TVA-SQN-TS-00-14

**SEQUOYAH NUCLEAR PLANT (SQN) -- UNITS 1 AND 2 -- TECHNICAL  
SPECIFICATION (TS) CHANGE NO. 00-14, SUPPLEMENTAL CHANGES  
(TAC NOS. MB6436 AND MB6437)**

UPDATED MARKUP PAGES  
FOR TECHNICAL SPECIFICATION (TS) CHANGE 00-14

FIGURE 3.4-2

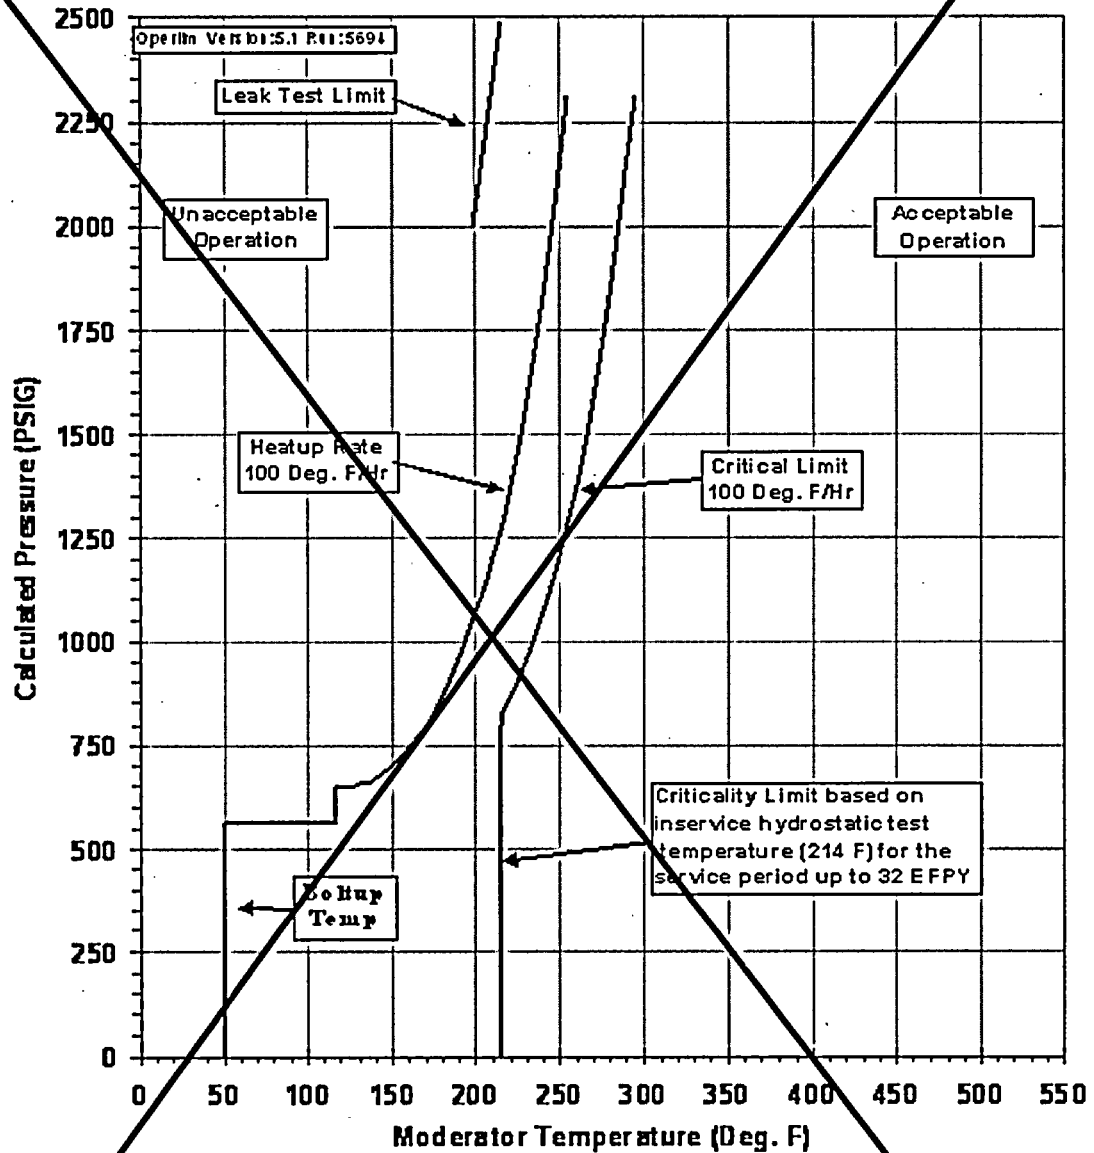
The first supplemental change provides for removal of the Unit 2 P-T limits that are currently contained in TS Figures 3.4-2 and 3.4-3. These P-T limits were incorporated into the SQN Unit 2 TSs under TS Change 03-08 for the purpose of replacing SQN's Unit 2 limits that expired July 2003. The TS Change 03-08 limits were developed with no exclusion for the flange region and were approved for use by NRC letter dated July 31, 2003. As discussed with the staff, these limits provide interim limits until the staff completes review of SQN's updated PTLRs (updated PTLRs are based on a site-specific exemption for exclusion of the flange region). Accordingly, the enclosed change removes the Unit 2 figures because these limits are superseded by the limits provided by the updated PTLRs.

DELETE FIGURE 3.4-2

FIGURE 3.4-3

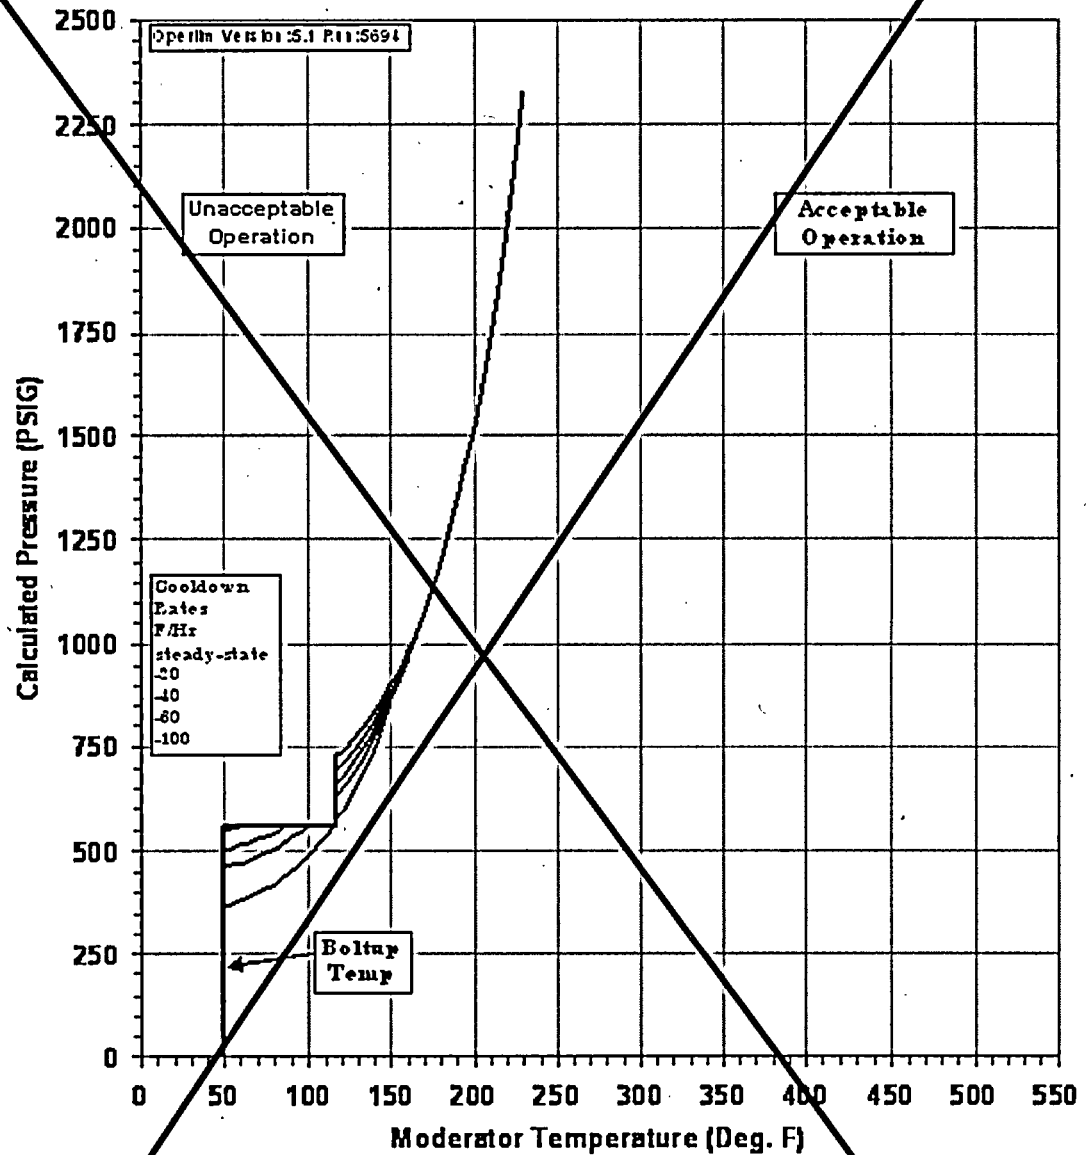
DELETE FIGURE 3.4-3
